SUBDIVISION & ZONING
AMENDMENT STAFF REPORT**Date: August 5, 2010****APPLICANT NAME**

McGregor Commercial Subdivision

LOCATION266 South McGregor Avenue
(Southeast corner of South McGregor Avenue and Berwyn Drive South).**CITY COUNCIL**
DISTRICT

SITE PLAN

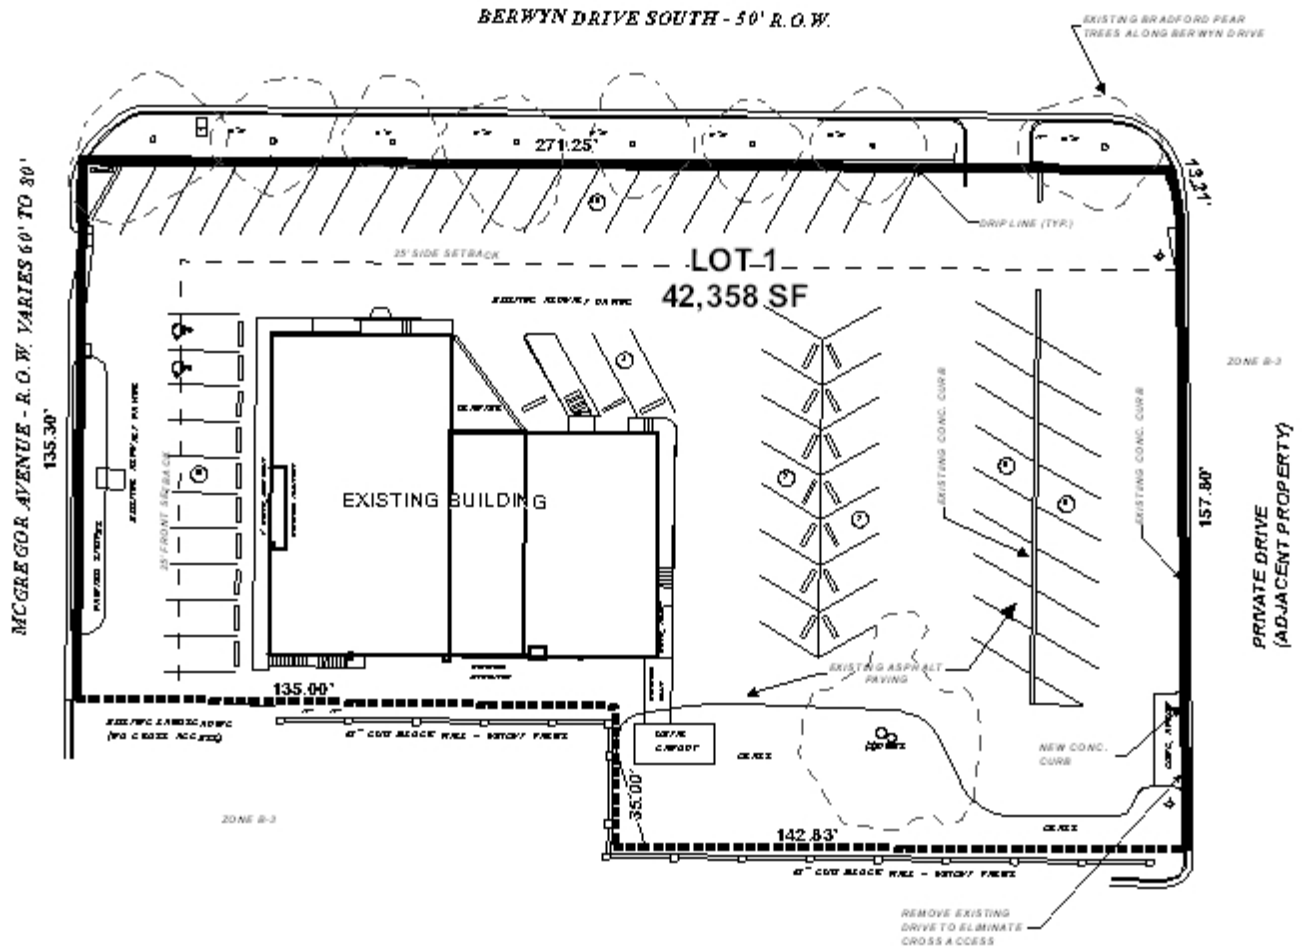
Driveway number, size, location, and design to be approved by Traffic Engineering and conform to AASHTO standards. Close the north driveway closest to Berwyn Drive and widen the south driveway to twenty-four feet in width.

Currently, the site is accessed by two curb cuts from South McGregor Avenue, one curb cut from Berwyn Drive South and a 24-foot internal curb cut from an adjacent property. The internal curb cut to the adjacent property will be closed off according to a note on the Final Plat stating that ingress/egress is not permitted from the adjacent properties unless a Planned Unit Development application is submitted and approved to allow such access. Lot 1 should be limited to the one curb cut to the development from South McGregor Avenue and one curb cut to Berwyn Drive South, with the size, location, and design of all curb cuts to be approved by Traffic Engineering and conform to AASHTO standards. Additionally, Traffic Engineering has requested that the site only be allowed one curb-cut onto McGregor and one onto Berwyn, and that the one curb-cut to McGregor be widened to meet minimum standards.

- 1) Placement of a note on the Final Plat limiting the development to two curb cuts (one curb cut to South McGregor Avenue and one curb cut to Berwyn Drive South) with the size, location, and design of all new curb cuts to be approved by Traffic Engineering and conform to AASHTO standards;

- 2) Compliance with Traffic Engineering comments (*Close the north driveway closest to Berwyn Drive and widen the south driveway to twenty-four feet in width.*)

- 3) Depiction and labeling of a 75-foot minimum building setback from the centerline of South McGregor Avenue on the Final Plat;
- 4) Placement of a note on the final plat stating that ingress/egress is not permitted from the adjacent properties unless a Planned Unit Development application is submitted and approved to allow such access;
